## **ADDENDUM NO. 3**

**TO:** All Bidders and Plan Holders  
**FROM:** Charlie Shell, Principal Engineer  
**PROJECT:** Construction of NE Veterans Drive – Phase II (No. 10444)  
**DATE:** February 1, 2013

## **ADDENDUM NO. 1**

**PROJECT:** Construction of NE Veterans Drive – Phase II  
No. 10444

SHEET NO.  
10 OF 10  
SHEET TITLE  
TS-10

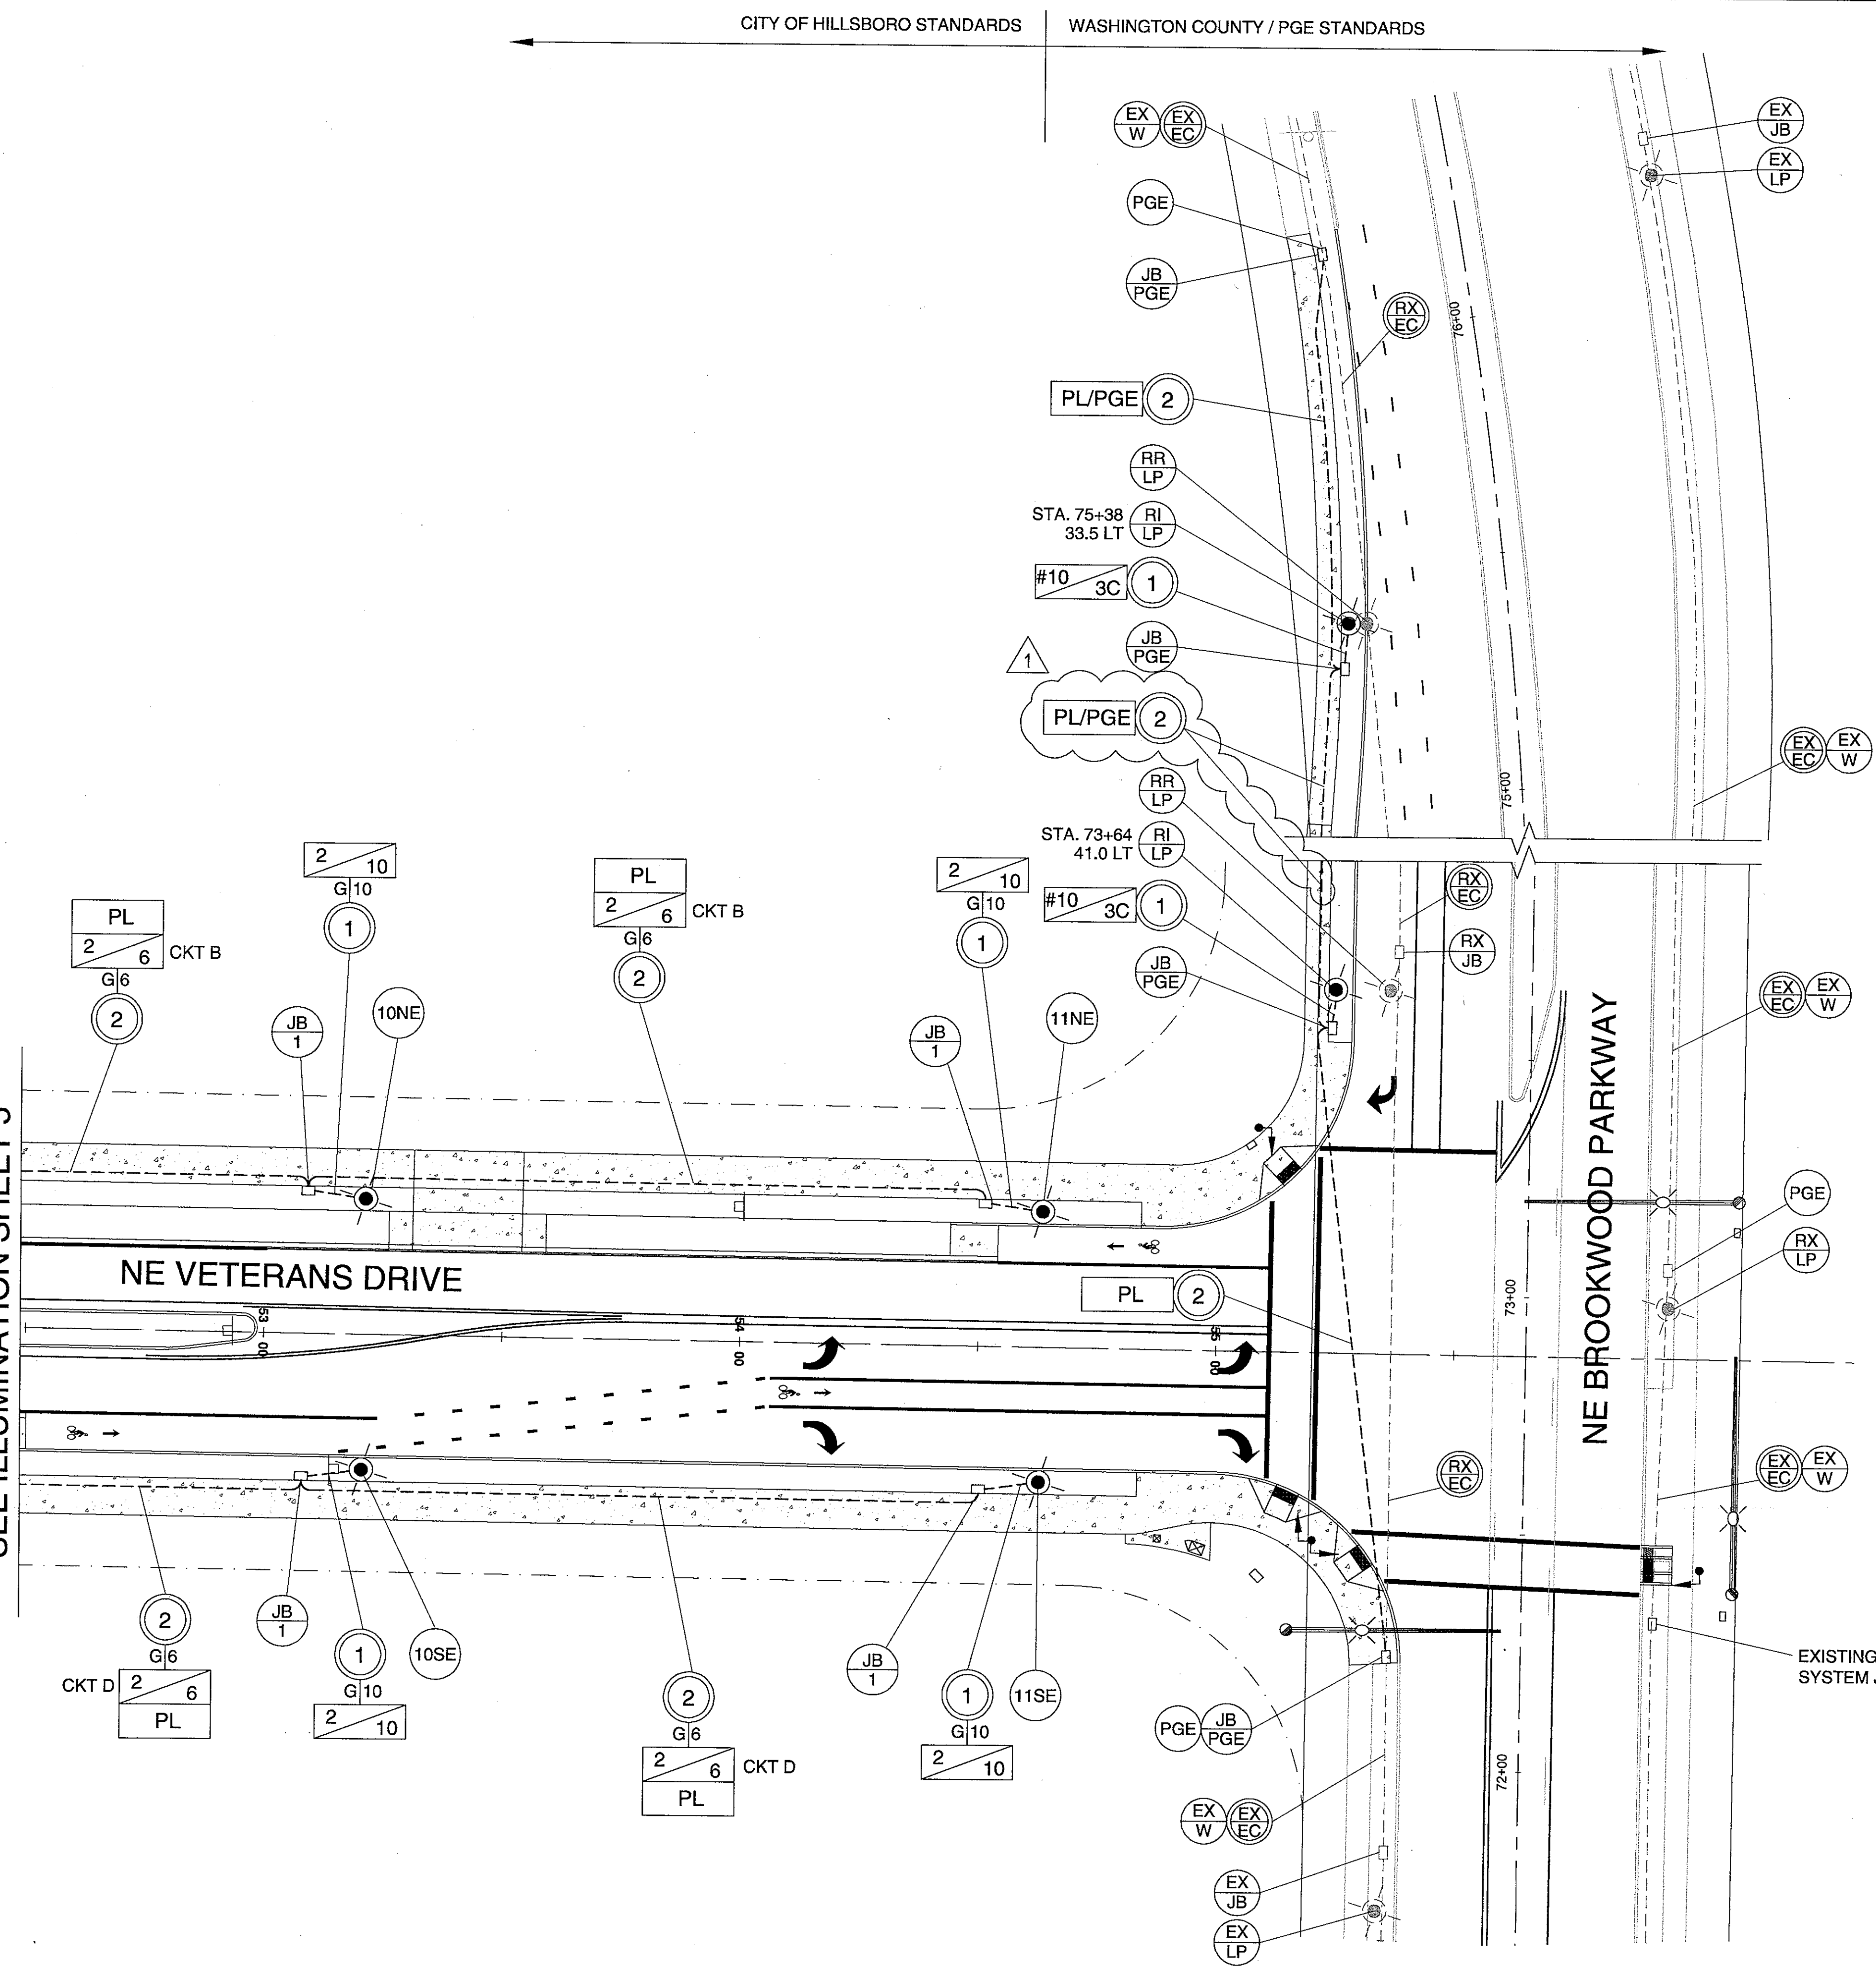
Sheets TS-1, TS-2, TS-4, TS-5, TS-8, TS-9, TS-10, of the traffic signal plans have been revised. The revised sheets issued with this addendum shall replace those sheets previously issued.

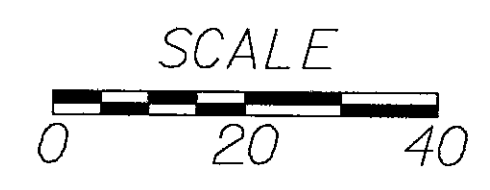
Sheets 1, 3, and 6 of the Illumination plans have been revised. The revised sheets issued with this addendum shall replace those sheets previously issued.
